Access Compliance Report

Public Rights-of-Way

(Pedestrian Signals)

Intersection ID: N/A	Main Street:	Cross Street: N/A	Location: N/A
ADA ID: E06DEB878254	Signal Type: Two Push Buttons-Non APS	Overall Compliance: No	Severity Score: BTN 1:N/A BTN 2: N/A No BTN: N/A
Codes/Mitigation Info/Possible Solution		Field Measurements/Component Compliance

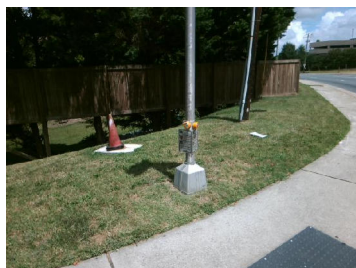
PROW/ADA: TMUTCD 4e.08, R404.2, R404.3, R406.2, R404.7.3

Yes	B 1 Clear Xing Direction?	ClearlyMarked	Yes	B 2 Clear Xing Direction?	ClearlyMarked
	B 1 Crossing Direction	To S		B 2 Crossing Direction	To E
Yes	B 1 DistanceTo XWalk (in)	0.0	Yes	B 2 DistanceTo XWalk (in)	0.0
No	B 1 DistanceTo Curb (in)	80.0	No	B 2 DistanceTo Curb (in)	80.0
Yes	B 1 Diameter (in)	2.0	Yes	B 2 Diameter (in)	2.0

Possible Solutions: Replace Signal Push Button With APS Button on New Post. Remove & Relocate Sign.
